Groundwater & Wastewater Services
Septic Project File & Data Review Worksheet

GWS File #: 3195 WASPS App #: 11832

Re: Application for improvement permit for: 3 Bedroom House
Property Location: 836 Breton Rd, Charlotte, NC 28278 (PID 053-042-03)
Health Department File Number: **3195 (App ID 11832)**

SOIL/SITE EVALUATION for ON-SITE WASTEWATER SYSTEM

PROPOSED PLOT PLAN

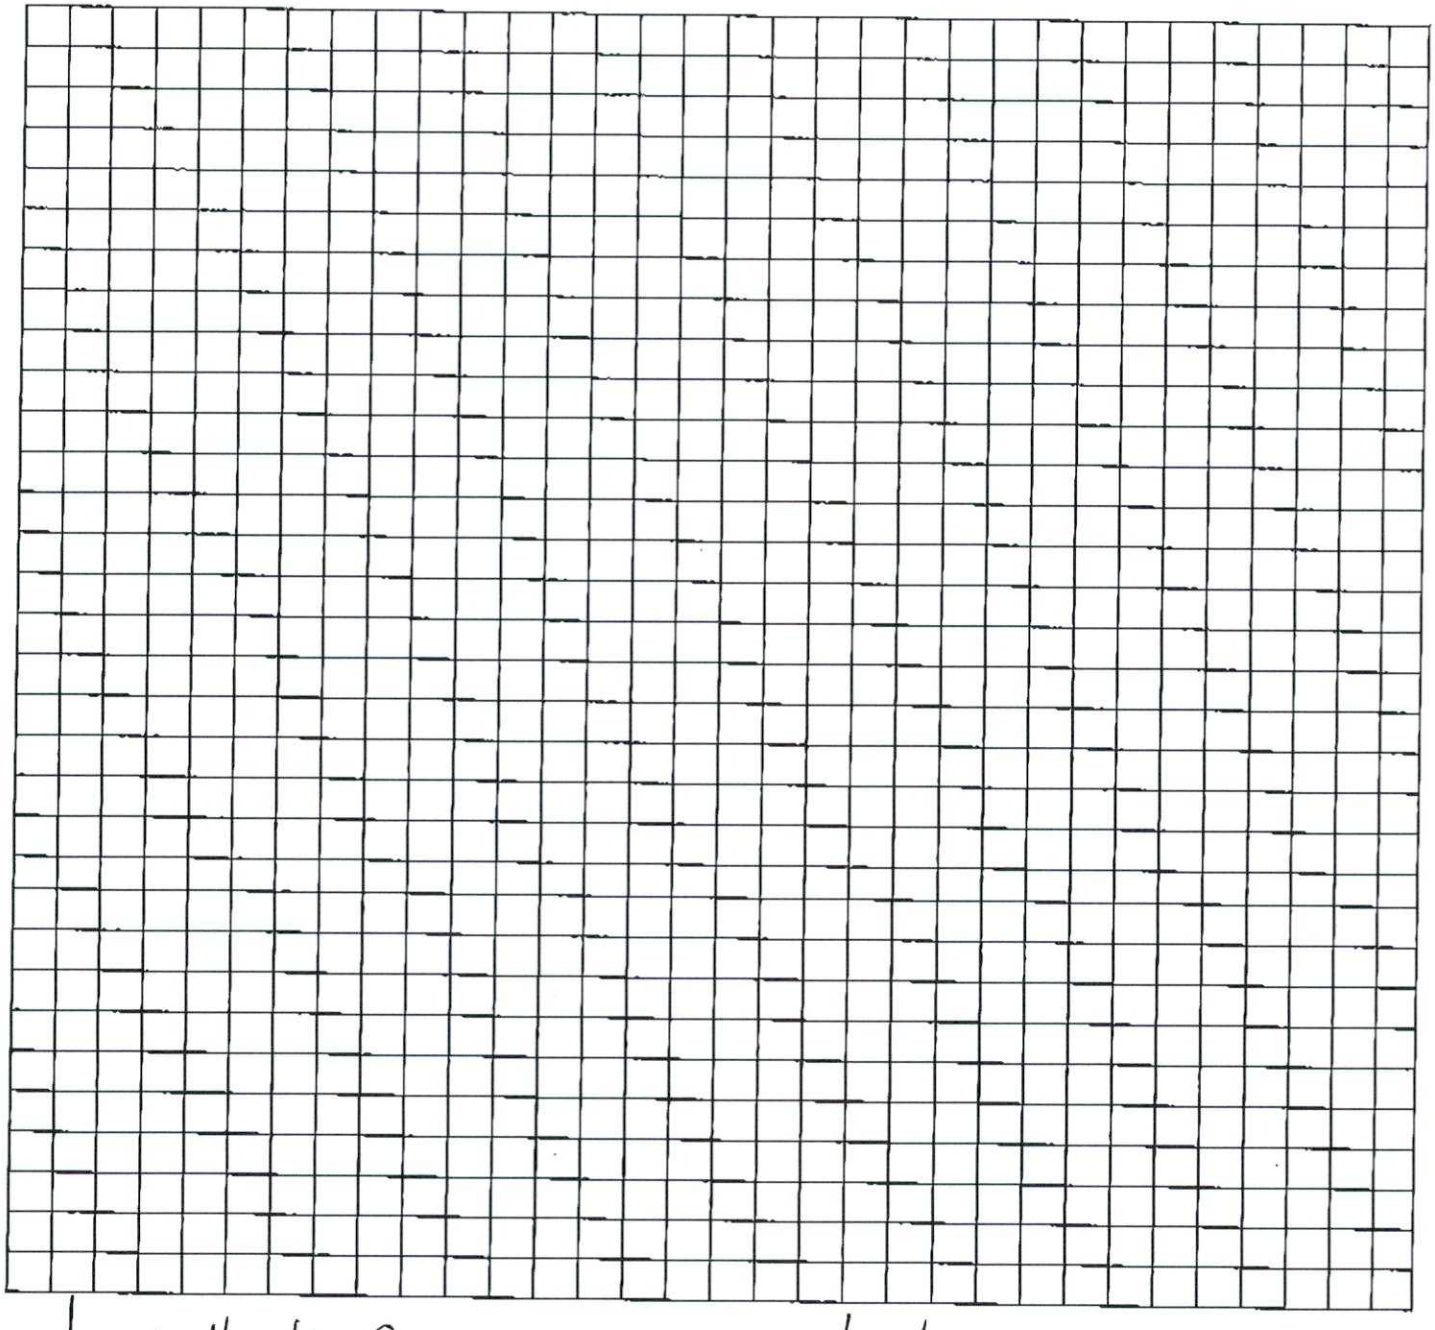
The Mecklenburg County Health Department, Environmental Health Division on January 6, 2021 evaluated the above-referenced property at the site designated on the site plan that accompanied your applicants improvement permit application. According to the application the site is to serve a 3 Bedroom Residence, with a daily design flow of 360 gallons per day. The evaluation was done in accordance with the laws and rules governing wastewater systems in North Carolina General Statute 130A-333 and related statutes and Title 15A, Subchapter 18A, of the North Carolina Administrative Code, Rule .l900 and related rules.

Based on the criteria set out in Title 15A, Subchapter 18A, of the North Carolina Administrative Code, Rules .1940 through .1948, the evaluation indicated that the site is **UNSUITABLE** for a ground absorption sewage system. Therefore, your request for an improvement permit is **DENIED.** A copy of the site evaluation is enclosed. The site is unsuitable based on the following:

- ☒ Unsuitable soil topography and/or landscape position (Rule .1940)
- ☒ Unsuitable soil characteristics (structure or clay mineralogy) (Rule .1941)
- ☒ Unsuitable soil wetness condition (Rule .1942)
- ☒ Unsuitable soil depth (Rule .1943)
- ☐ Presence of restrictive horizon (Rule .1944)
- ☒ Insufficient space for septic system and repair area (Rule .1945)
- ☐ Unsuitable for meeting required setbacks (Rule .1950)
- ☐ Other (Rule .1946)

However, the site classified as **UNSUITABLE** may be classified as **PROVISIONALLY SUITABLE** if written documentation is provided that meets the requirements of Rule .1948(d). A copy of this rule is enclosed. You may hire a consultant to assist you if you wish to try to develop a plan under which your site could be reclassified as **PROVISIONALLY SUITABLE.**

Sketch of Soil Evaluation Locations

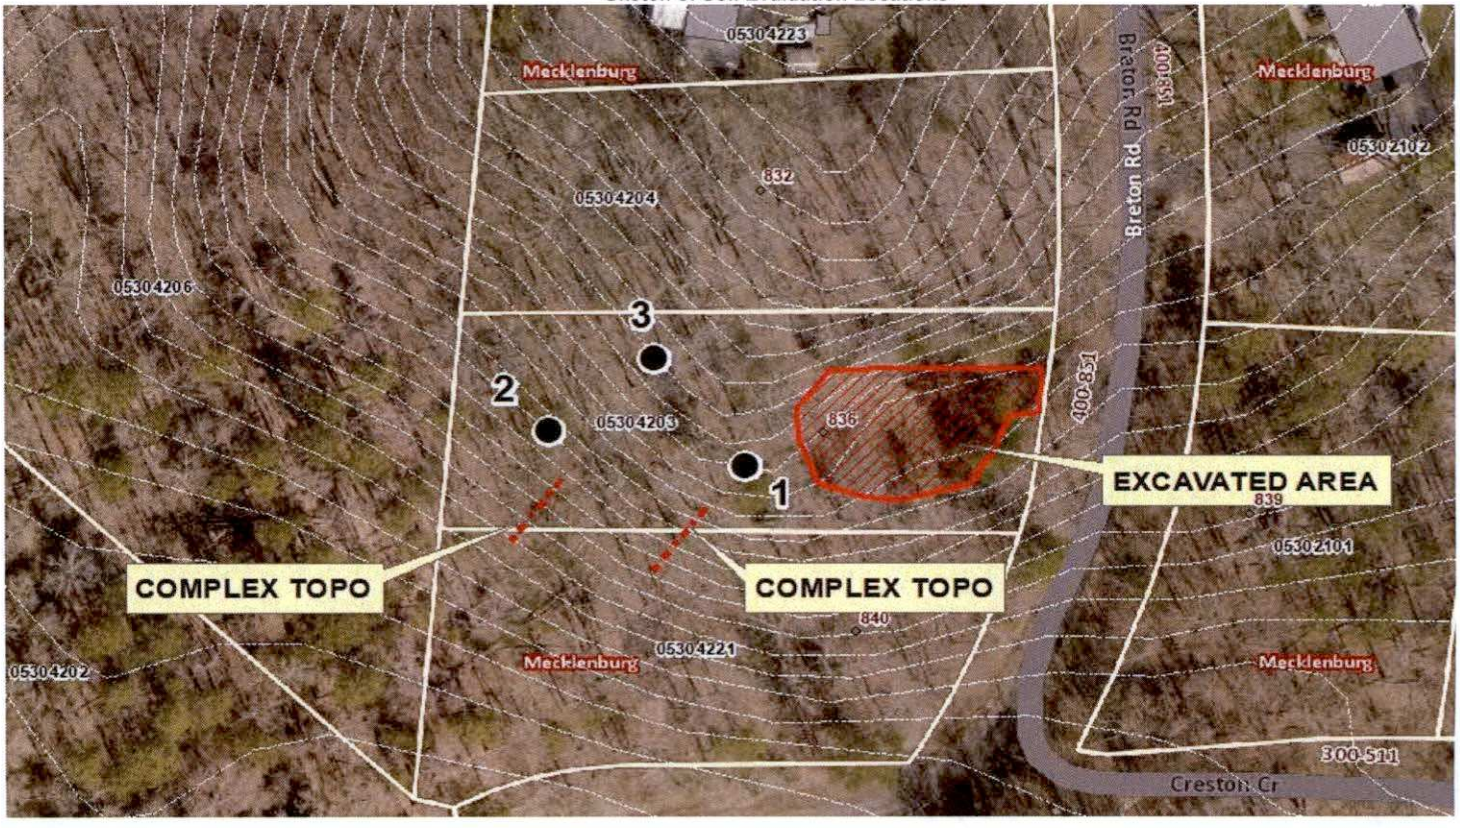
PROFILE #	.1940 Landscape Position/ Slope%	Horizon Depth (IN.)	SOIL MORPHOLOGY .1941 .1941 Structure/ Texture	.1941 Consistence Mineralogy	b PROFILE FACTORS .1942 Soil Wetness/ Color	.1943 Soil Depth (IN.)	.1956 Sapro Class	.1944 Restr Horiz	General Comments	Profile Class & LTAR	Maximum Trench Bottom Depth for 3' Wide Conventional Trench
Boring #1	LS 16%	0 - 8	sbk CL	SS SP FR SEXP	10 YR 7/1 at 11"	8	NA	NA		US	NA
		8 - 15	mass C	S VP VFI EXP							
		15 - 24	Saprolite	NA							
		24 - 28	Rock with Saprolite								
Boring #2	LS 18%	0 - 8	gr SCL	SS SP FR SEXP	10YR 6/1 at 10"	8	NA	NA		US	NA
		8 - 25	mass C/SC	S P VFI EXP							
Boring #3	LS 16%	0 - 12	gr SCL	SS SP FR SEXP	10YR 7/1 at 29"	29	NA	NA	Need Pit for 20 - 36"	US	NA
		12 - 20	sbk SCL	SS SP FR SEXP							
		20 - 36	sbk/mass C	S P FI SEXP

Other Factors (.1946):
Soil Evaluation By: Jacob Presley, REHS, LSS
Others Present:
Site Classification (.1948): Unsuitable
Site Evaluation By: Jacob Presley, REHS, LSS
Others Present:
